STAFF REPORT
COMMUNITY DEVELOPMENT DEPARTMENT

HEARING DATE: March 18, 2021
TO: Planning & Zoning Commission
FROM: Sonya Allen, Associate Planner
208-884-5533
SUBJECT: H-2020-0074
TM Center - PP
Ten Mile Crossing – MDA, RZ
LOCATION: East of S. Ten Mile Rd. & south of W.
Franklin Rd., in the north half of Section
14, Township 3N., Range 1W.

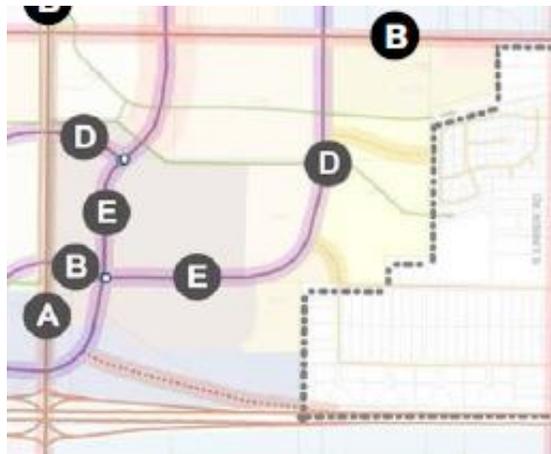
Two (2) driveway accesses via Franklin Rd. are depicted on the plat – one to the east and one to the west of New Market/Benchmark on Lot 4, Block 3 and Lot 4, Block 4. The conceptual

development plan included in the DA for the Bainbridge Franklin property depicts the eastern driveway access via Franklin; however, the Applicant states this property is no longer planned to develop in that manner. ACHD has *not* approved either of these accesses and is requiring a traffic analysis be submitted to demonstrate additional driveways are necessary to serve the site. The UDC's (11-3A-3) intention is to improve safety by combining and/or limiting access points to arterial streets to ensure motorists can safely enter all streets. **City Council should determine if a waiver to the standards in UDC 11-3A-3 is appropriate for the proposed driveway accesses in the absence of a conceptual development plan for this area.** These accesses are prohibited unless specifically approved by the City and ACHD.

- l. Remove the two (2) driveway accesses depicted on the plat via Franklin Rd. on Lot 4, Block 3 and Lot 4, Block 4 to the east and west of New Market/Benchmark unless specifically approved by City Council through a waiver to UDC 11-3A-3, which limits access to arterial streets, *and* by ACHD.

STREET SECTION: S. WAYFINDER AVE.
SCALE: NTS

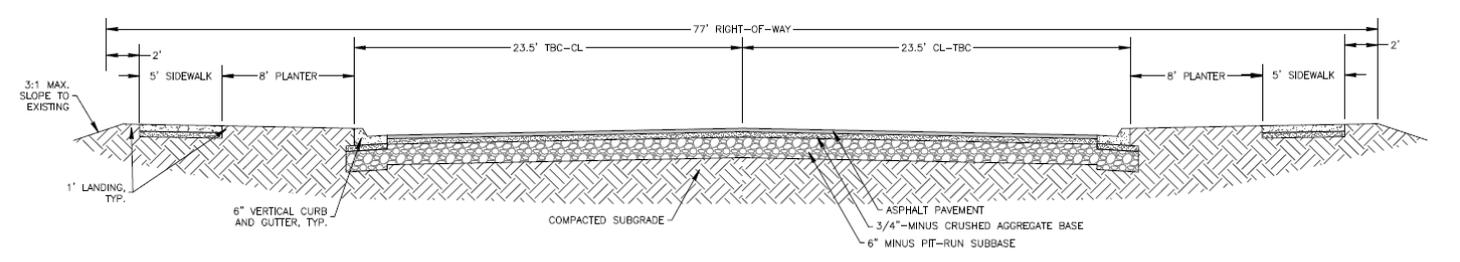
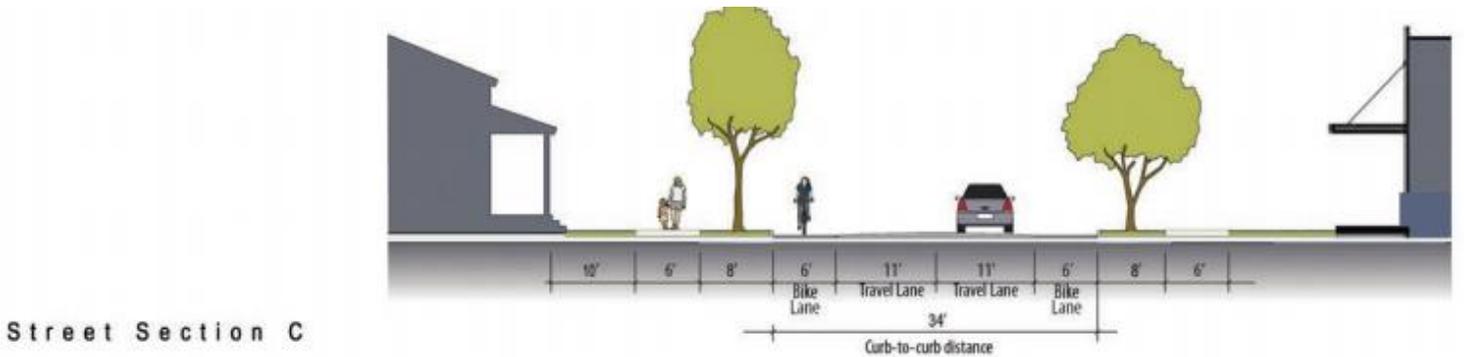
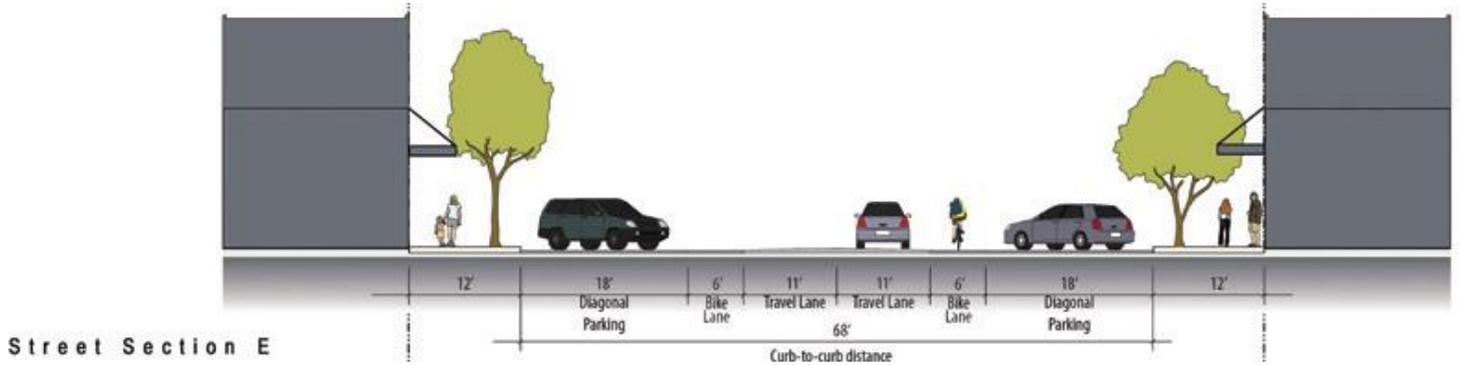
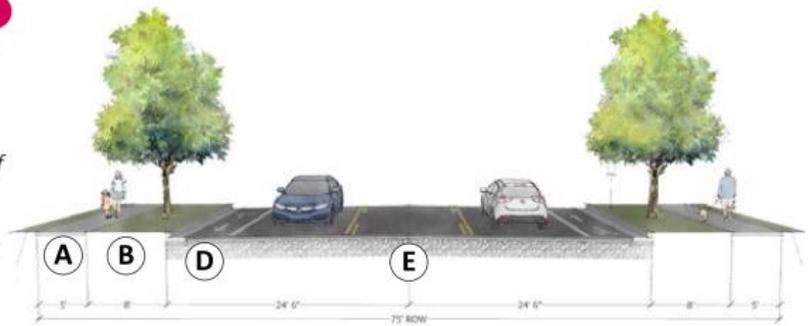
The western north/south collector street, proposed as S. Wayfinder Ave., designated as “E” (minor collector street), extends from a future signalized intersection at W. Franklin Road to the south to Vanguard. The portion north of Cobalt was approved with TM Creek subdivision. **Per the Map and as required by the existing DA for Ten Mile Center, this street should have been constructed per the guidelines for Street Section E shown below with two (2) travel lanes, bike lanes, diagonal parking and 12’ sidewalks with trees in wells (see pgs. 3-21 & 3-23 in the TMISAP). However, the street section approved by ACHD and constructed is a standard street section with (2) travel lanes, a center turn lane, bike lanes, 8-foot wide planter strips, a 5-foot wide detached sidewalk on the west side and an 8-foot wide pathway on the east side with no on-street parking, similar to that of major collector street (i.e. Street Section C, shown below) (see street section from the proposed plat and detail from the proposed design guidelines below). Because of the changes to the FLUM in this area from LC to Commercial and this street providing access to the employment uses to the south, which will likely result in a higher traffic volumes, Staff is in general support of the design as constructed. Minor collector streets in the Plan differ from the MSM’s town center collector street in that they don’t have a center turn lane and have diagonal instead of parallel parking.**

STREET SECTION: S. NEW MARKET AVE.

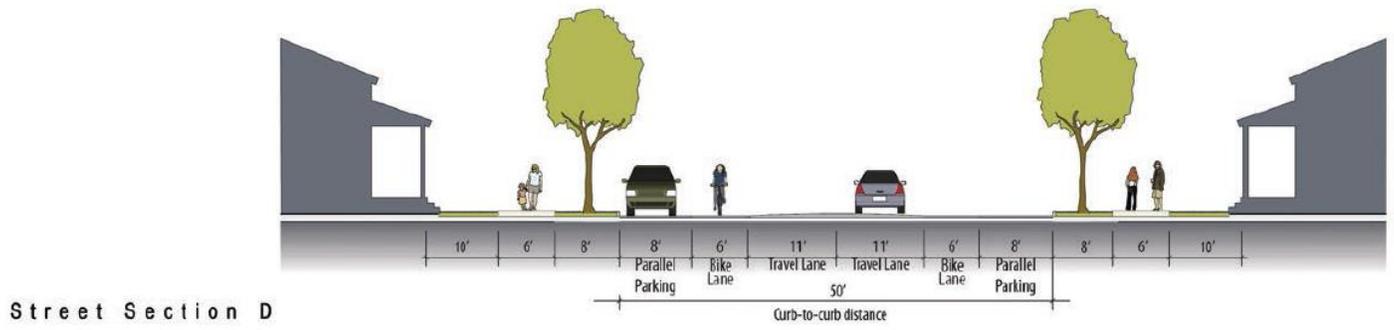
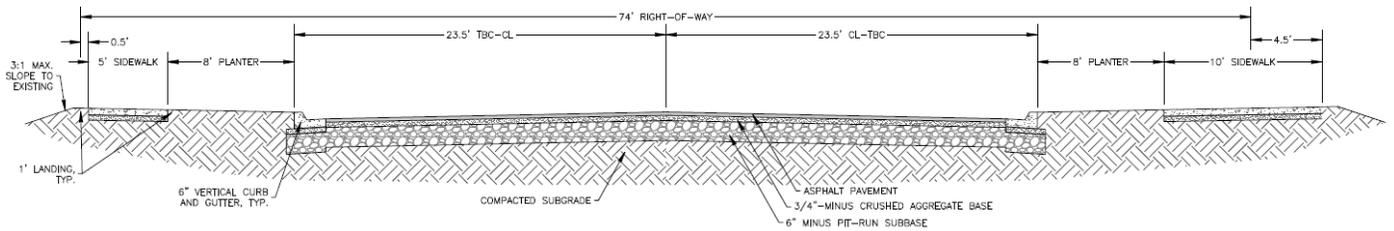
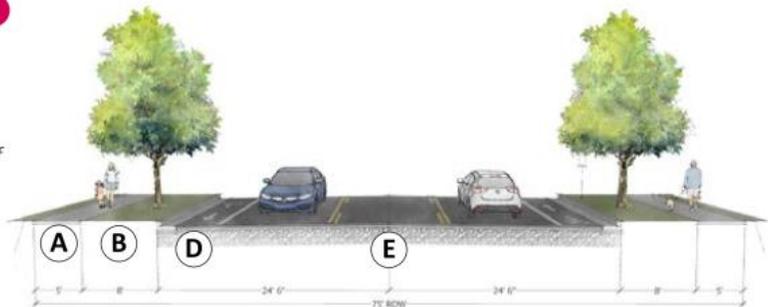
The eastern north/south collector street proposed as S. New Market Ave./Benchmark Ave., designated as “D” (residential collector street), will extend from Franklin Rd. to the south boundary of the site and connect to Navigator Dr. in the TM Crossing project. **This street should be constructed in accord with the guidelines for Street Section D shown below with two (2) travel lanes, bike lanes, parallel on-street parking (if allowed by ACHD), 8’ tree-lined parkways and detached sidewalks per the TMISAP and as required by the existing DA’s for Ten Mile Center and Calnon (see pgs. 3-21 & 3-23 in the TMISAP).**

The street section from the proposed plat and a detail from the proposed design guidelines shown below differ from a residential collector street in that there is a center turn lane, wider travel lanes and no on-street parking. ACHD has approved the proposed design; however, Staff does *not* support the proposed design as it’s not consistent with the TMISAP and the existing DA’s and therefore, recommends revisions consistent with Street Section D below with on-street parking. ACHD will have to review and approve revised street sections if changes are required to the proposed design – although on-street parking is desired and recommended, ACHD will need to review and determine if it’s safe to provide. *Staff discussed the discrepancies between the proposed plat and the town center collector in the MSM and Street Section D with ACHD and was told that although the Livable Street Design Guide allows for parking on a collector street it isn’t always appropriate in all locations – because we don’t know the end users for lots adjacent to these streets (a conceptual development plan or use plan wasn’t submitted) it’s difficult to determine if on-street parking will be appropriate. Residential collector streets in the Plan differ from the MSM’s town center collector street in that they don’t have a center turn lane and have a wider buffer zone.*

- d. South New Market Ave./Benchmark Ave. shall be constructed with two (2) travel lanes, bike lanes, parallel parking (if allowed by ACHD), 8-foot wide parkways and detached sidewalks/pathways consistent with Street Section D in the TMISAP, the development agreement, Pathways Master Plan and pathway plan for the site. *The first 200' of south of Franklin Rd. on New Market is not allowed to have on-street parking per the ACHD report to allow for right and left turn lanes.*

- b. Depict a minimum 5-foot wide detached sidewalk along the west side of S. New Market Ave./Benchmark Ave. where 8- to 10-foot wide pathways are not proposed on the pathway plan, with 8-foot wide parkways within a minimum 20-foot wide landscaped buffer in accord with the TMISAP for Street Section D (see pg. 3-21).

STREET SECTION: W. COBALT DR.

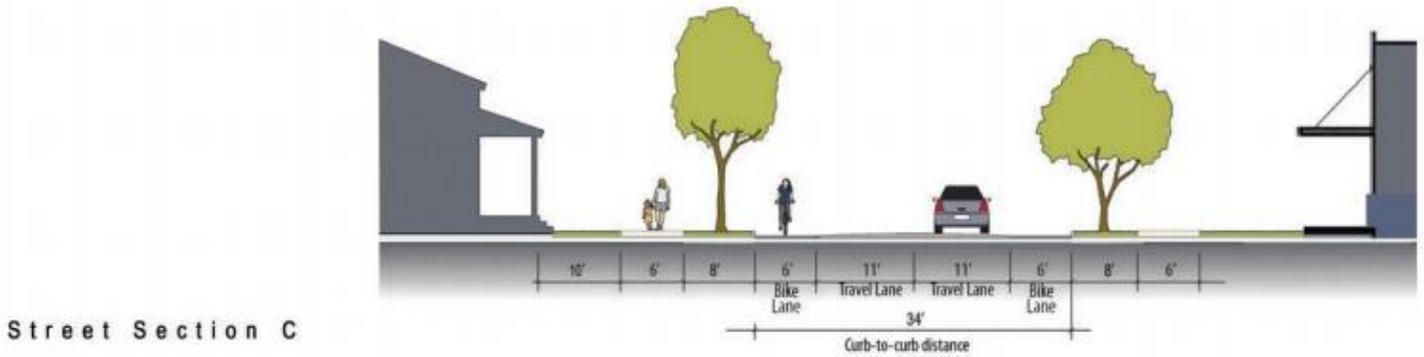
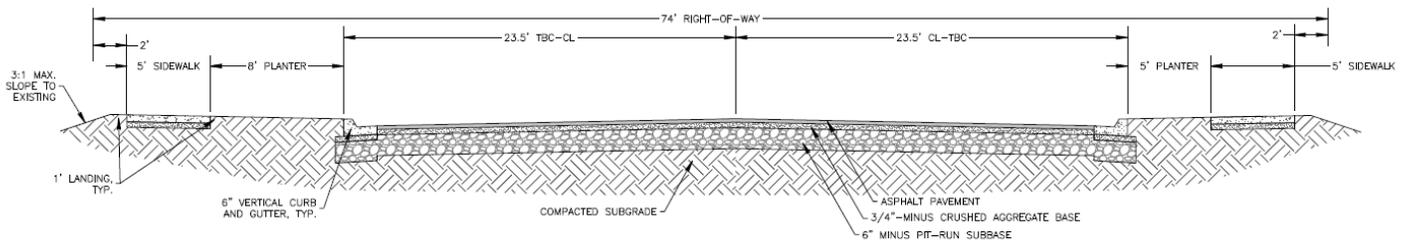
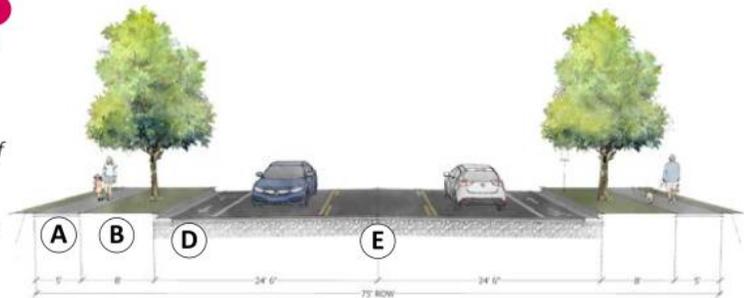
Neither the SSM shown above, nor the MSM, depicts an east/west collector where W. Cobalt Dr. is proposed to extend between Wayfinder and New Market although it does depict such further to the south in alignment with the access via Ten Mile Rd. along the southern boundary of this site which was actually constructed further to the south (i.e. Navigator Dr.) as discussed above. This southern section is designated as a minor collector street (“E”) on the Street Section Map in the TMISAP and as a town center collector on the MSM. The portion of Cobalt west of Wayfinder is designated as a residential collector street (Street Section D) but was approved to be constructed as a major collector street closely aligning with Street Section C due to residential uses not being planned at that time in that area – since that time, the development plan changed and multi-family residential uses have been constructed along the north side of the street, east of S. Innovation Ln.

Street Section C, the street section from the plat and a detail from the proposed design guidelines are shown below. The western portion of Cobalt in front of the TM Creek East apartments project was previously approved as part of ACHD’s action on that project and has been constructed.

- c. Depict a minimum 20-foot wide street buffer, landscaped per the standards listed in UDC 11-3B-7C, along each side of W. Cobalt Dr., a collector street; and a detached 8- to 10-foot wide pathway on the south side of the street consistent with the pathway plan.

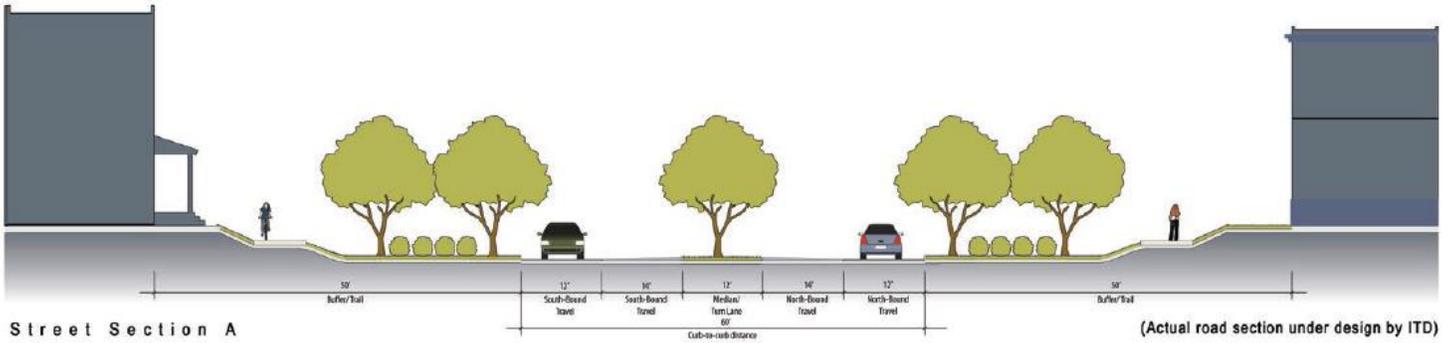
South Ten Mile Rd., an existing arterial street along the west boundary of the site, is designated as a modified 4-lane parkway (“A”) on the Street Section Map. **Buildings should address the street but be set back some distance from the roadway to provide security to the pedestrians and bikes and a wide tree lawn and detached trail should be provided as shown on Street Section A below. Streetlights should be located in the tree lawn area and should be of a pedestrian scale. Dry utilities should be located back of the curb in the dry utilities corridor.**

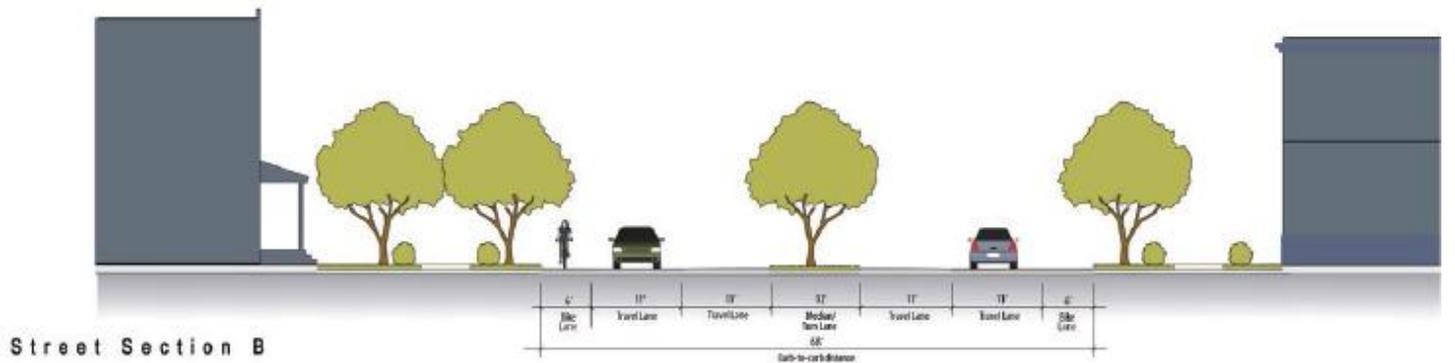
West Franklin Rd., an existing arterial street along the north boundary of the site, is designated as a typical 4-lane parkway (“B”) on the Street Section Map. **Buildings should address the street but be set back some distance from the roadway edge to provide for a tree lawn and detached sidewalk to provide security to the pedestrian as shown on Street Section B below. Streetlights should be located in the tree lawn area and be of a pedestrian scale. Dry utilities should be located back of the curb in the dry utilities corridor.**
